Access Compliance Report

Public Rights-of-Way (Curb Ramps)

Intersection ID: 46815	Main Street: OLDE_IVY_WY	Cross Street: ARBOR_CREST_CT	Location: E
ADA ID: 2212E4D4BBEF	Ramp Type: Perp	Initial Pass/Fail: Fail	Overall Compliance: No
		Severity Score: 8.75

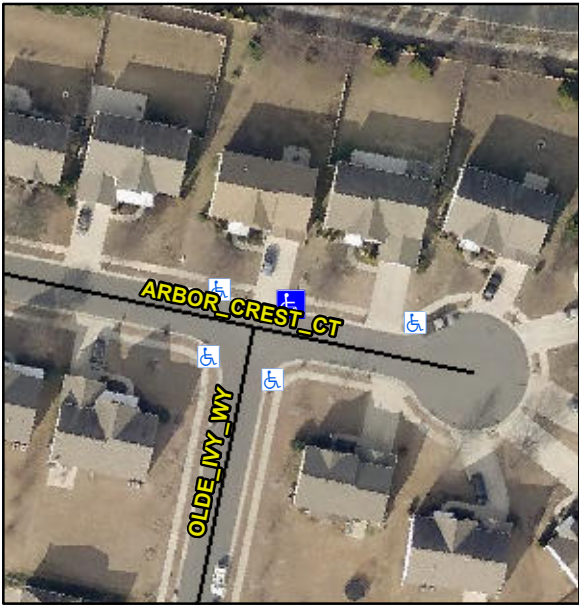
Codes/Mitigation Info/Possible Solution				Field Measurements/Component Compliance					
	Possible Solutions:			Compliance	Description	Data	Compliance	Description	Data
	Remove & Replace Entire Ramp.			N/A	Ramp Length (in)	46.5	Yes	Ramp Slope (%)	6.9
				No	Ramp Width (in)	47.0	Yes	Ramp XSlope (%)	1.4
				N/A	Flare Type LT	N/A	N/A	Flare Type RT	N/A
				N/A	Flare Slope LT (%)	N/A	N/A	Flare Slope RT (%)	N/A
				N/A	Flare Traversable LT?	N/A	N/A	Flare Traversable RT?	N/A
				N/A	Landing Length (in)	N/A	N/A	DWS Provided?	N/A
				N/A	Landing Width (in)	N/A	N/A	DWS Contrast?	N/A
				N/A	Landing Slope (%)	N/A	N/A	DWS Length (in)	N/A
				N/A	Landing X Slope (%)	N/A	N/A	DWS Full Width?	N/A
Surveyor Notes:			N/A	N/A	Landing Curb? (Y/N)	N/A	N/A	DWS Offset (in)	N/A
PROW/ADA:			R304.5.1	N/A	Shared Landing?	N/A	N/A	Gutter Slope (%)	N/A
				N/A	Gutter Ponding?	N/A	N/A	Gutter X Slope (%)	N/A
				N/A	Gutter Lip Ht (in)	N/A	N/A	Gutter X Slope (%)	N/A
